Damodar Valley Corporation

Comments

Draft CERC (Terms and Conditions of Tariff) Regulation 2024

CHART-2

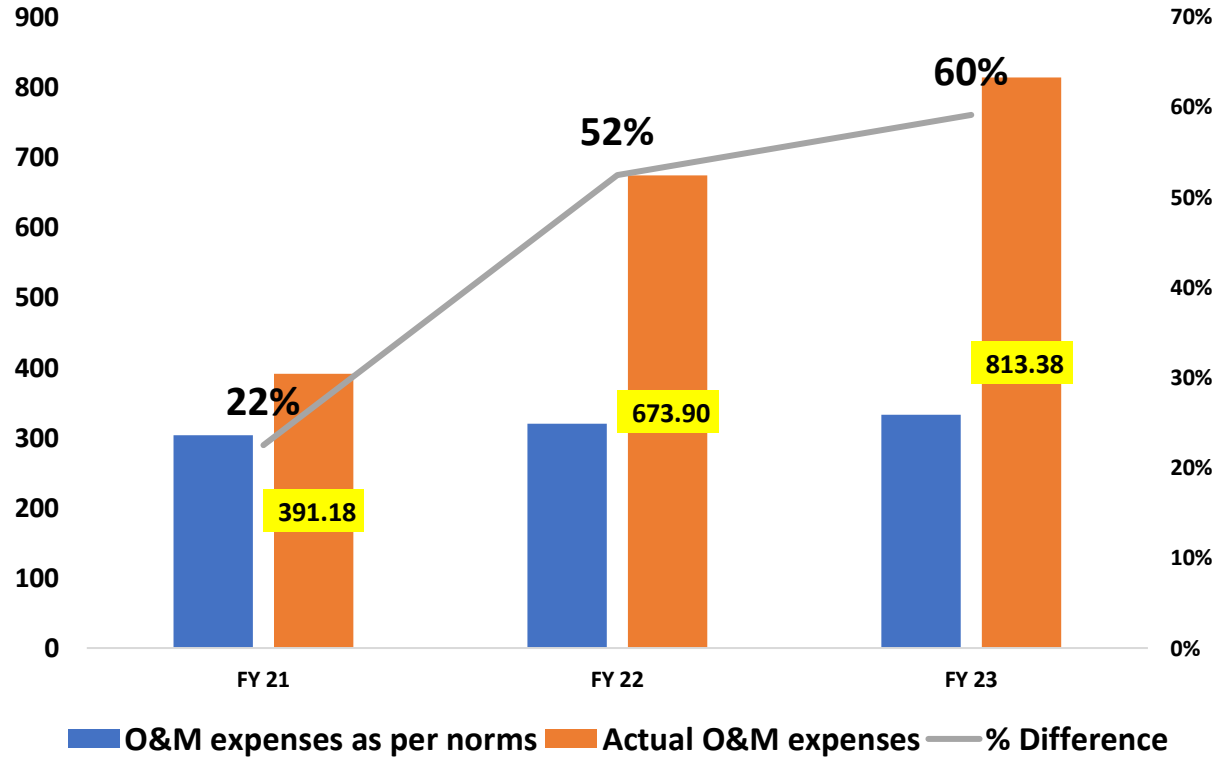
A comparison of Normative V/s Actual O&M expenses for T&D System of DVC of the last four years depicts huge under-recovery owing to higher actuals over the norms [[Chart-2](#)] even after achieving NTAF.

CHART-3

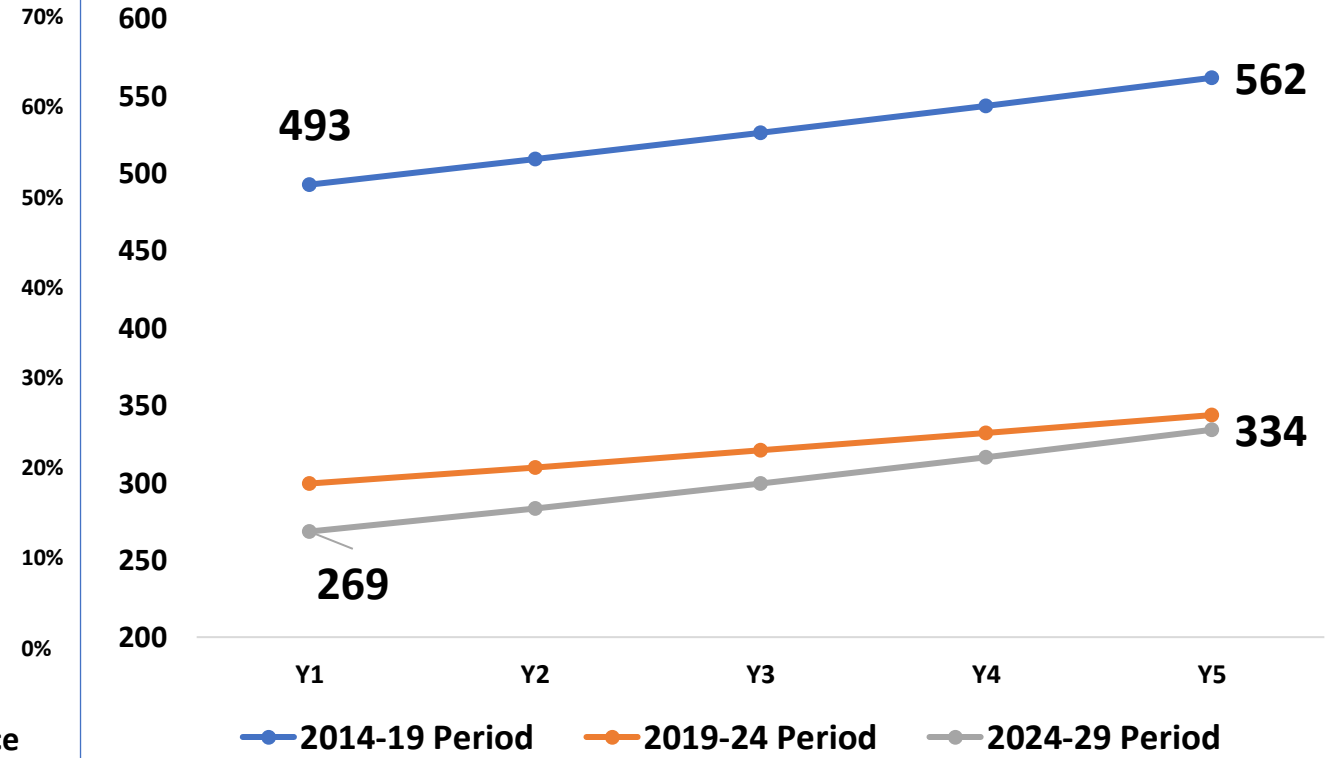
- Norms for Transformers to be based on no. of transformers rather than capacity (unjustified for T&D assets like DVC). O&M for a single 500 MVA Transformer is not the same for 10 nos. of 50 MVA transformer. Moreover, DVC caters Distribution System for which O&M tends higher and for which separate O&M for distribution function is not allowed by State Electricity Regulatory Commissions (i.e. WBERC and JSERC)
- O&M norms for T&D activities reduced rapidly over last three control periods [[Chart-3](#)] even though the actual O&M expenses have been increasing at least at the rate of inflation.
